Date: October 12, 2006

Subject: Request for additional information regarding FCC ID: IHDT6GM1

Correspondence Reference Number:	IHD0507
Confirmation Number:	1608280507/508
Date of Original Email:	October 9, 2006

Figure 1. Part 15 Radiated Test Set-Up

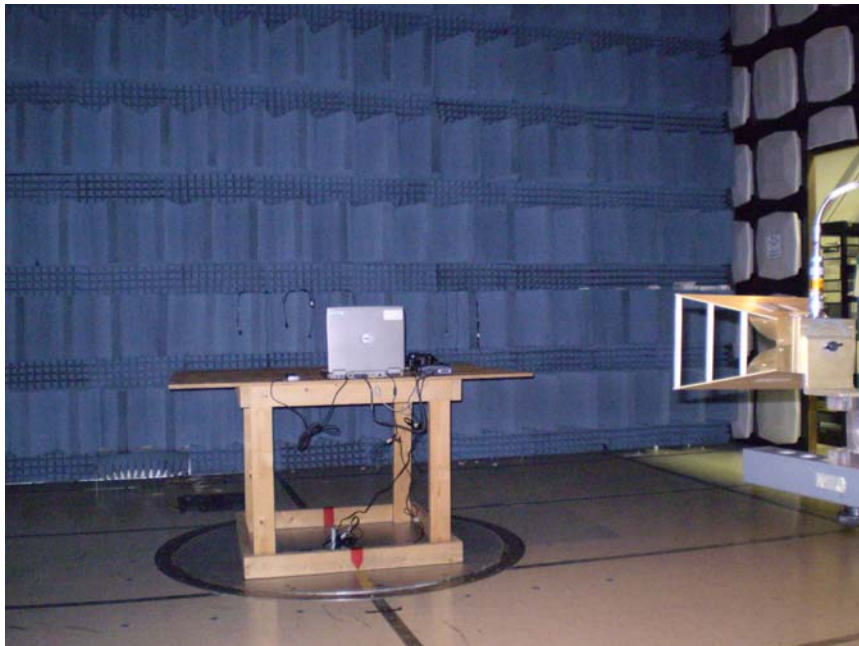
2. Please submit Part 15B test set up photos (both radiated and AC Line Conducted) as well as Part 24 EMC test set up photos (the test set up photo submitted does not show the EUT).

Response: Please refer to the following photos:
